**JSCC WORKFORCE DEVELOPMENT BUILDING  
SCO # 22-24540-02A**

**CMAR ADDENDUM NO. 3 (CM3)**

ISSUED ON: FEBRUARY 19, 2025

## Monteith Construction RFI Log

10 Typical Linear Section Detail  
A5.3 Scale: 1 1/2" = 1'-0"

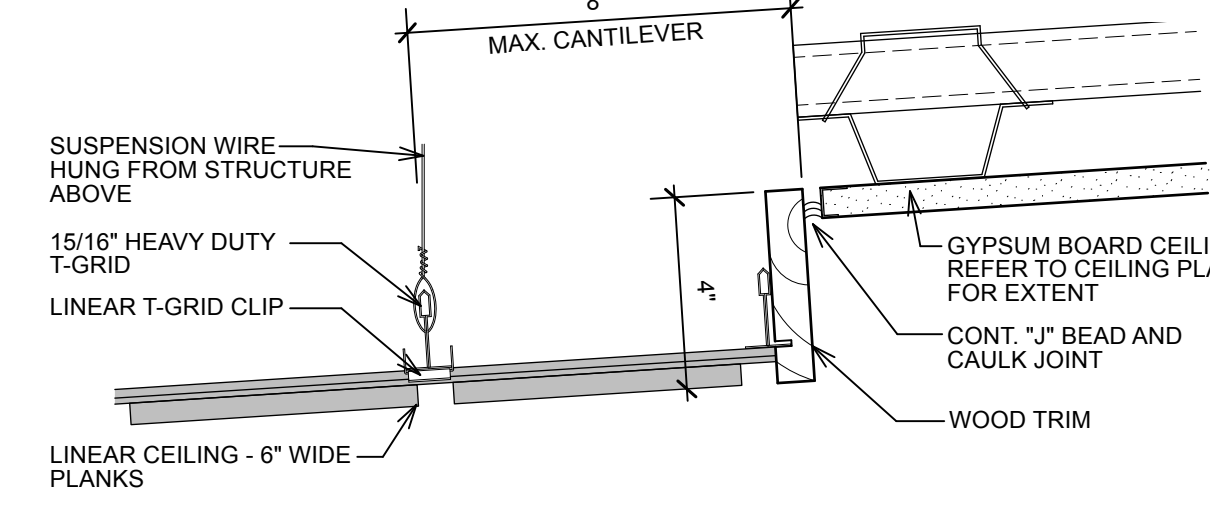
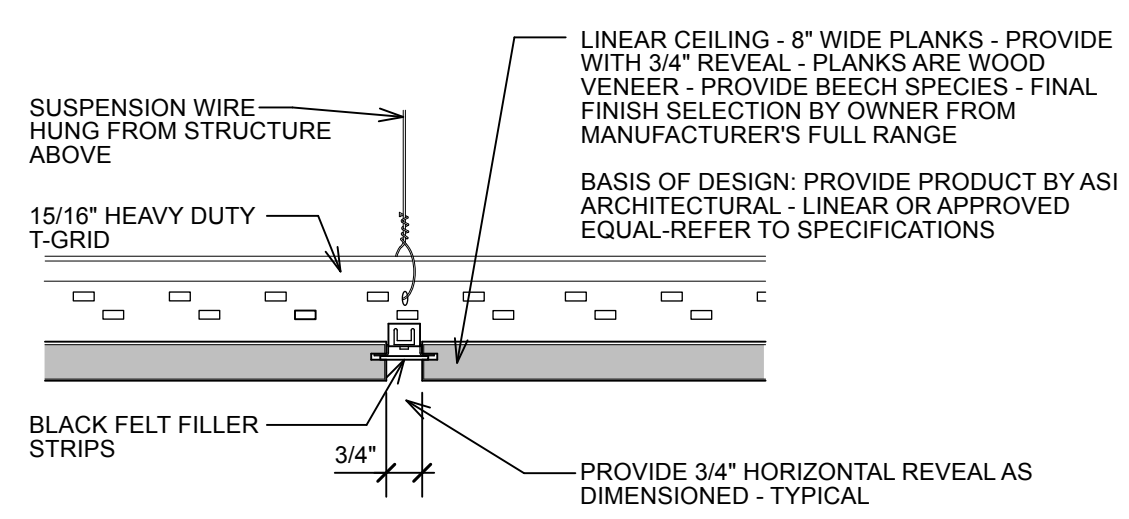
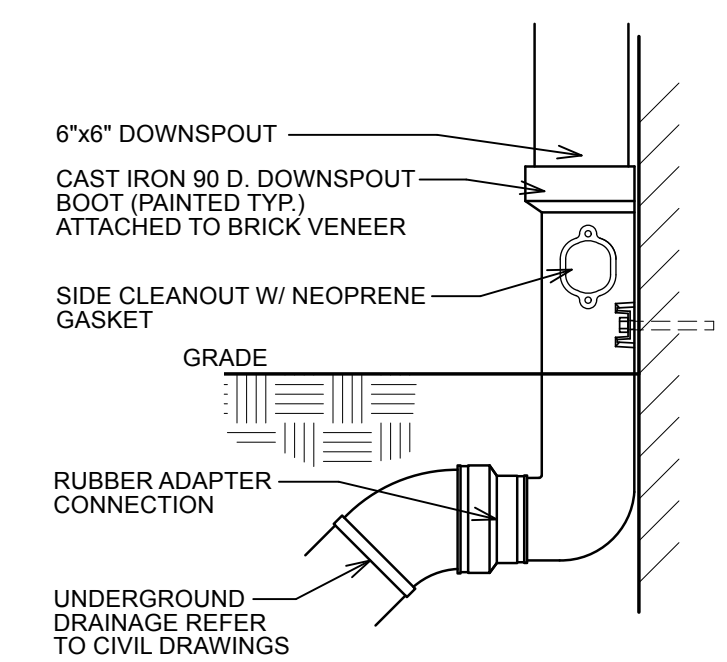
**Item 22                    Drawings A5.3 - Clarification (RFI #70)**

Request for information was made about the dimensioned 12’ on the linear reveal wood veneer wall in Lobby 101. Planks may be joined by manufacturers standard detail in a butt joint to achieve the 12’ between reveals as shown on the drawings. Butt joints to be randomized. Notes have been added for clarification to drawing A5.3. Revised drawing A5.3 is included as **Attachment #8**.

5 Wall Section  
A5.3 Scale: 3/4" = 1'-0"

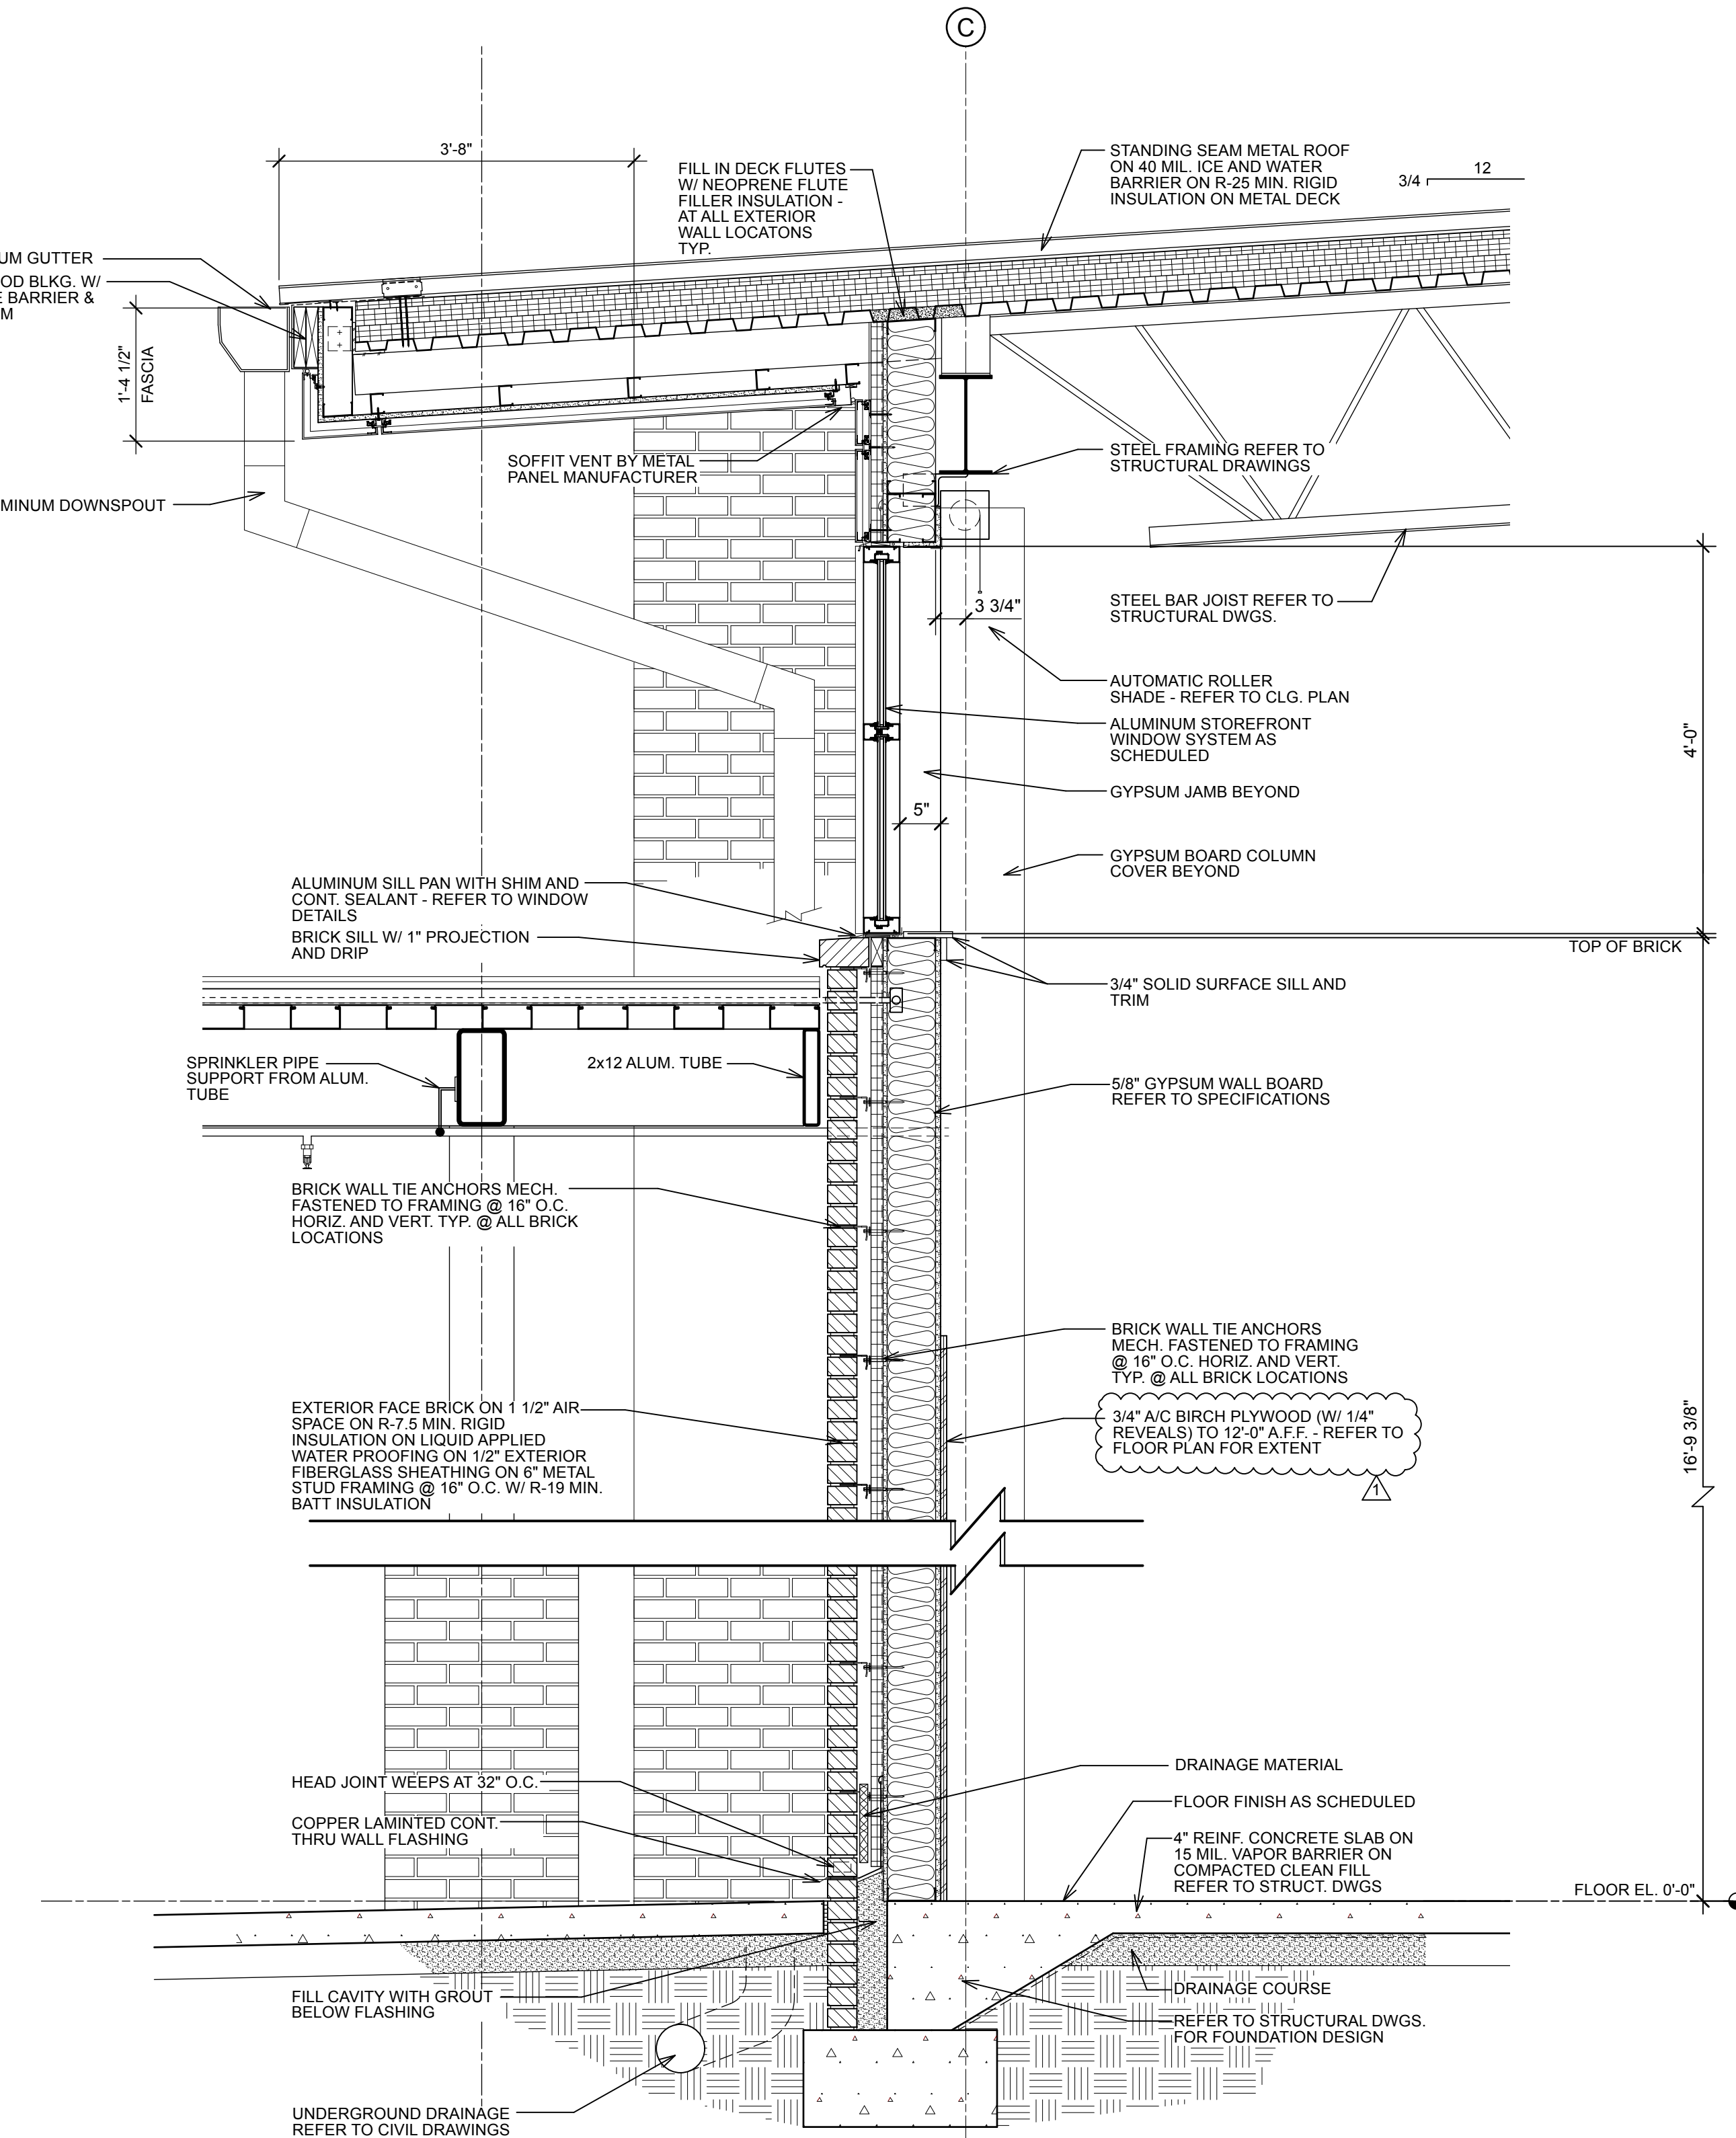
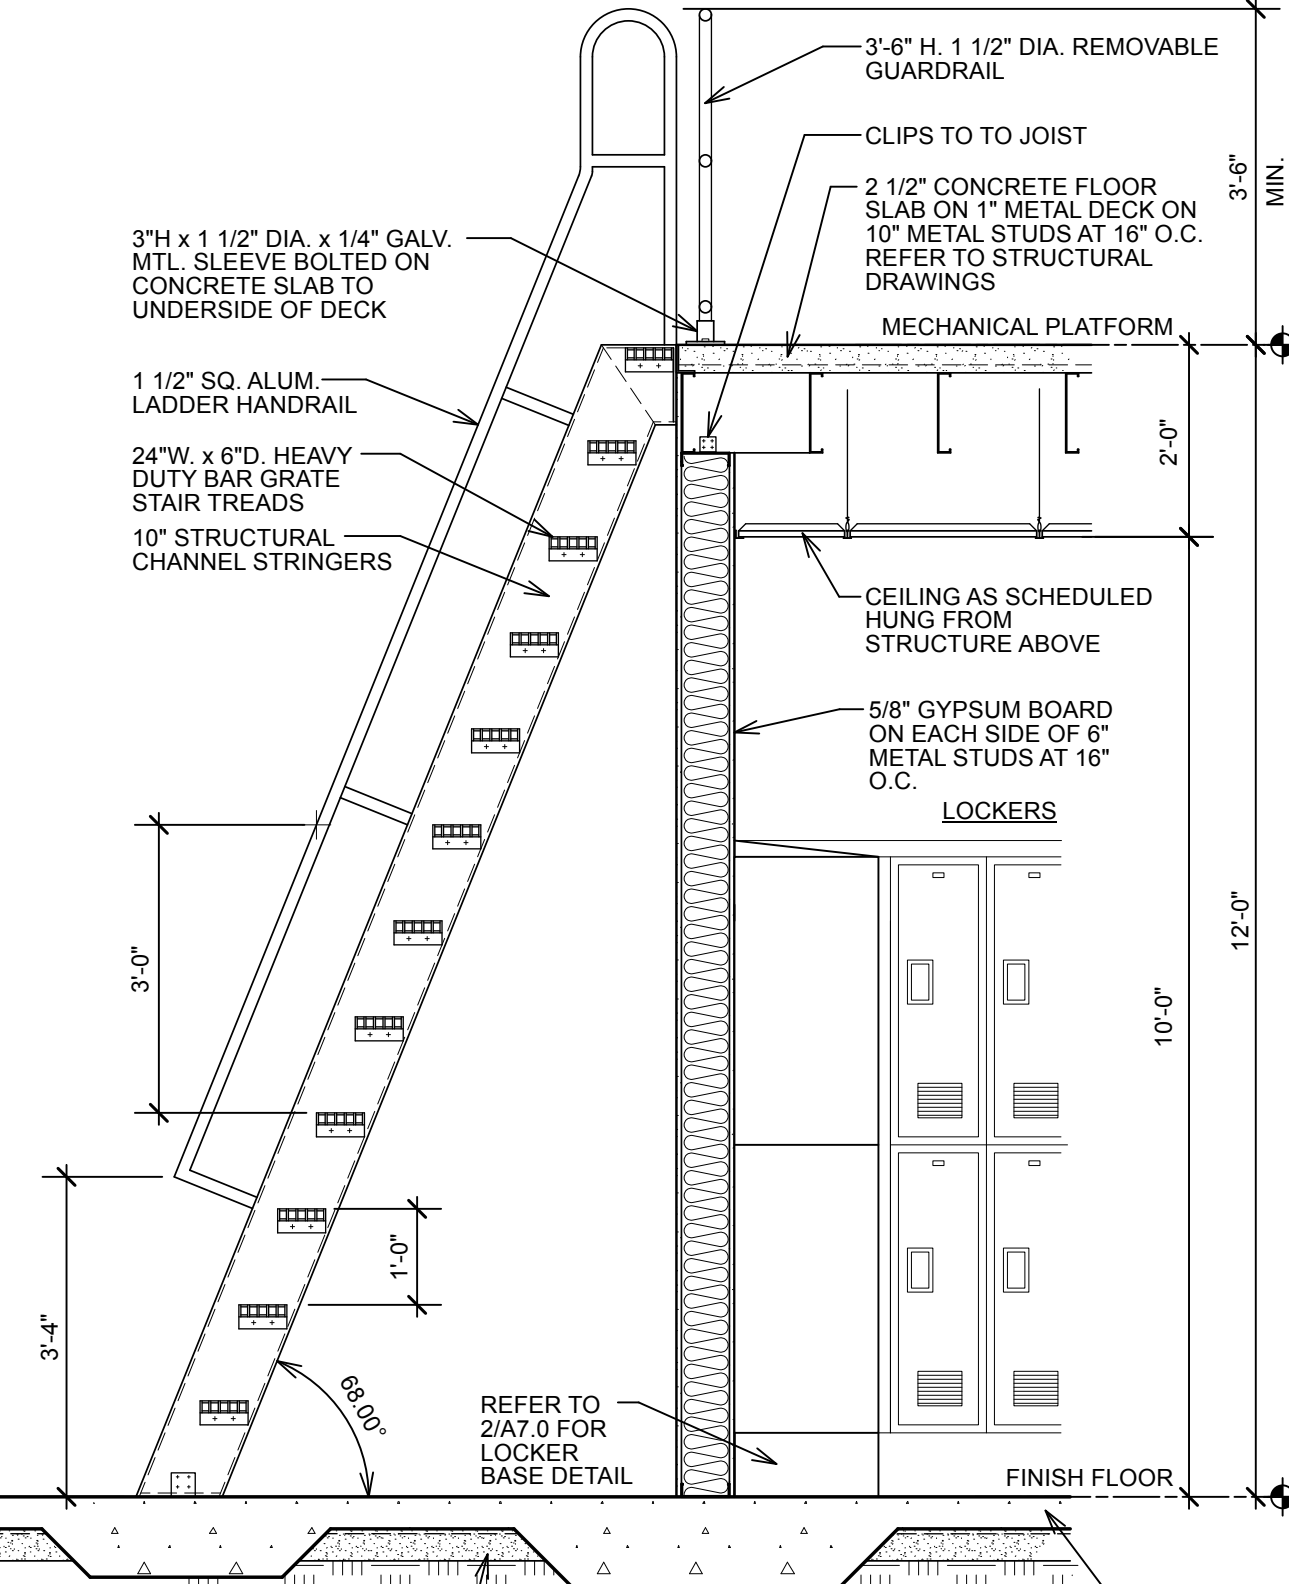
- Item 34                    Drawings A5.3 - Revision (RFI #90)**
- Drawing 5/A5.3 incorrectly called for fire rated plywood. Revised drawing A5.3 is included as **Attachment #8**.

REV.	DATE	DESCRIPTION
02-17-25	ADDENDUM #5	
01-21-25	ADDENDUM #3	
NO.	DATE	ISSUE NOTE
Project Manager		Drawn By
WAC		HGH
Date		Reviewed By
12-18-2024		WAC
Project ID		CBHF: 22093
Sheet Title		
ELECTRICAL FLOOR PLAN - POWER		
Sheet No.		
EP1.1 Addendum 5, Attachment 10

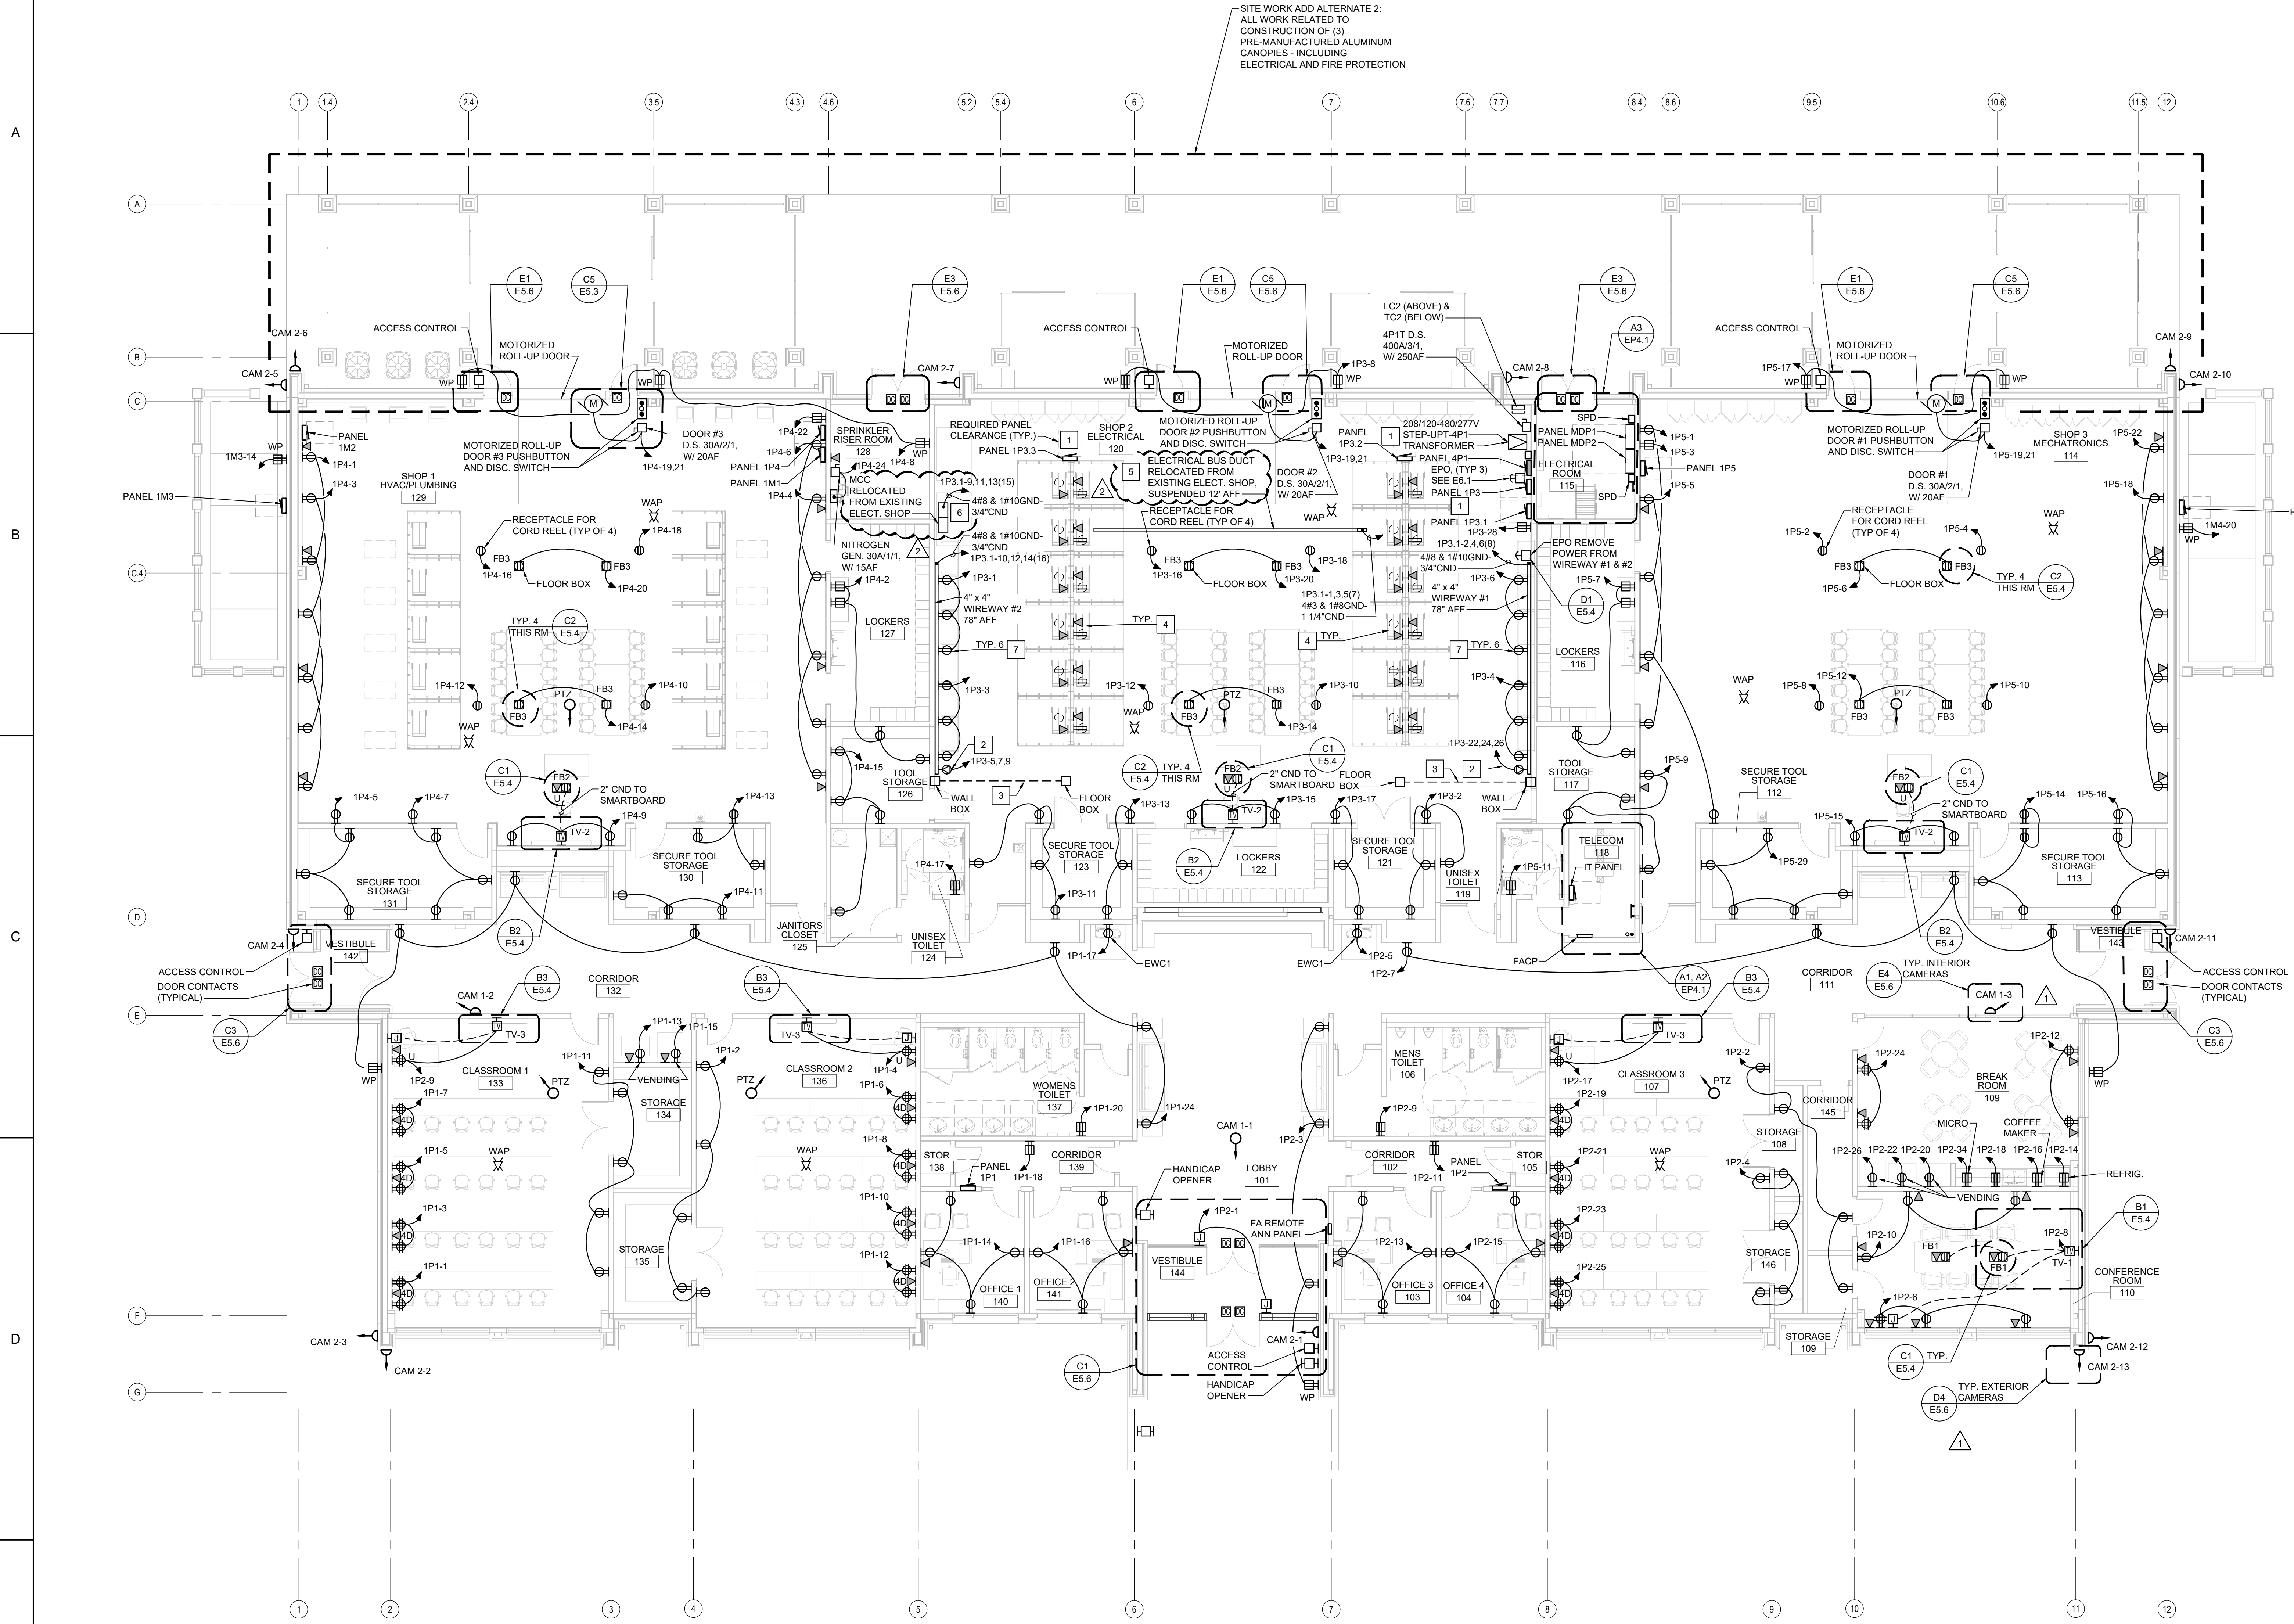
- Item 41                    Electrical Drawing EP1.1 – Revisions**
- Drawing EP1.1 has been revised to clarify the removal and relocation of the existing MCC and existing Bus Duct. The MCC and Bus Duct are existing and are currently located in Hall Building in the existing Electrical Shop/Lab. The electrical contractor is responsible for disconnecting the existing MCC and Bus Duct and all associated hardware and re-installing in Workforce Development Building in Shop 2 Electrical [120] as indicated on EP1.1. Revised drawing EP1.1 is included as **Attachment #10**.
